November 1, 2018

Product Improvement Notice - Launch of Gen II hydraulic leveling jacks

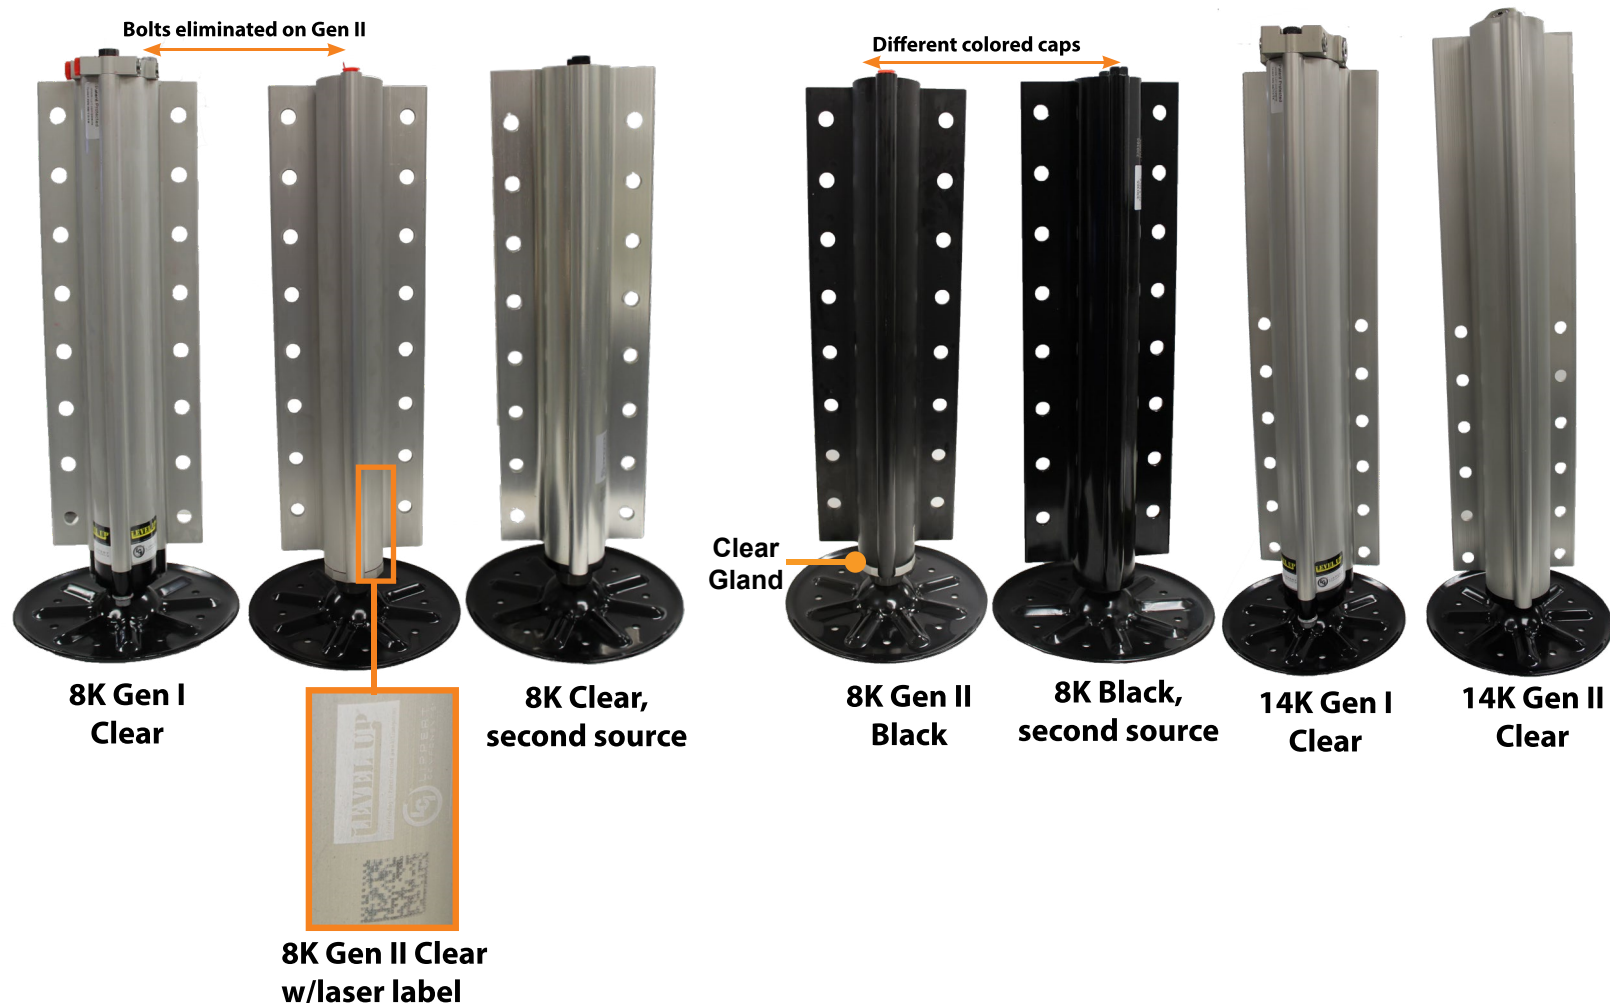
The LCI Gen II jacks are assembled with precision automation, which increases both the quality and consistency of the product. The new jack design eliminates all assembly bolts, which in turn, cuts the number of external seal points in half. Reducing the number of external seal points drastically reduces the number of potential leak points.

The rod for the levelers will remain the same size as Gen I, but the overall jack length on Gen II is .25" shorter than Gen I. The mounting hole pattern is flipped from Gen I to Gen II, which moves the Gen II jack lower to the ground by .375", creating .375" less ground clearance. There is no change in installation of the Gen II jacks. The jacks are interchangeable, but Gen I will only be offered for warranty replacement.

The Gen II jacks will also have a clear gland as opposed to a black gland on Gen I. The change to the clear gland will be made on a running basis as inventory dictates.
